# Access Compliance Report

## Public Rights-of-Way

Intersection ID: 8600	Main Street: NEWELL_ACRES_DR	Cross Street: NEWELL-HICKORY_GROVE_RD	Location: SW
ADA ID: 858DFC7CCEB0	Ramp Type: Perp	Initial Pass/Fail: Fail	Overall Compliance: No
Severity Score: 37.5			
Codes/Mitigation Info/Possible Solution		Field Measurements/Component Compliance

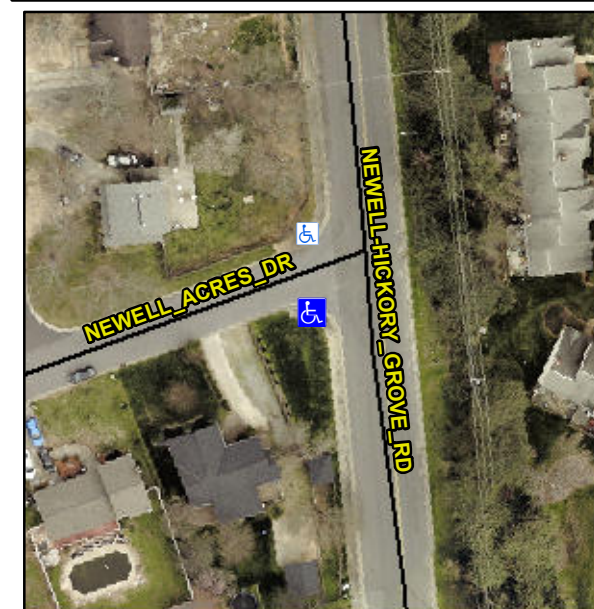
**Not Found, R304.5.1, R304.2.2, R304.5.3, R302.7**

Compliance	Description	Data	Compliance	Description	Data
N/A	Ramp Length (in)	59.5	No	Ramp Slope (%)	10.7
No	Ramp Width (in)	47.5	No	Ramp XSlope (%)	4.6
N/A	Flare Type LT	N/A	N/A	Flare Type RT	N/A
N/A	Flare Slope LT (%)	N/A	N/A	Flare Slope RT (%)	N/A
N/A	Flare Traversable LT?	N/A	N/A	Flare Traversable RT?	N/A
N/A	Landing Length (in)	N/A	N/A	DWS Provided?	N/A
N/A	Landing Width (in)	N/A	N/A	DWS Contrast?	N/A
N/A	Landing Slope (%)	N/A	N/A	DWS Length (in)	N/A
N/A	Landing X Slope (%)	N/A	N/A	DWS Full Width?	N/A
N/A	Landing Curb? (Y/N)	N/A	N/A	DWS Offset (in)	N/A
N/A	Shared Landing?	N/A			
N/A	Gutter Ponding?	N/A	N/A	Gutter Slope (%)	N/A
N/A	Gutter Lip Ht (in)	1.5	N/A	Gutter X Slope (%)	N/A
N/A	Painted X Walk1?	No	N/A	Painted X Walk2?	N/A
	X Walk 1 Direction	To N		X Walk 2 Direction	N/A
N/A	X Walk 1 Width (in)	N/A	N/A	X Walk 2 Width (in)	N/A
	X Walk 1 Slope (%)	3.3		X Walk 2 Slope (%)	N/A
	X Walk 1 X Slope (%)	6.1		X Walk 2 X Slope (%)	N/A

N/A	Ramp inside XWalk1?	N/A	N/A	Ramp inside XWalk2?	N/A
	Road Slope (%)	N/A	N/A	Clear Space?	N/A
	Road X Slope (%)	N/A	N/A	Clear Space to XWalk (in)	N/A
N/A	Any Obstructions?	N/A	N/A	Storm Grate/Utility Hazard?	N/A
	Obstruction Type			Storm Grate/Utility Type	
		N/A			N/A
		No		Surface Condition? (G/P)	Poor

**Remove & Replace Entire Ramp.**
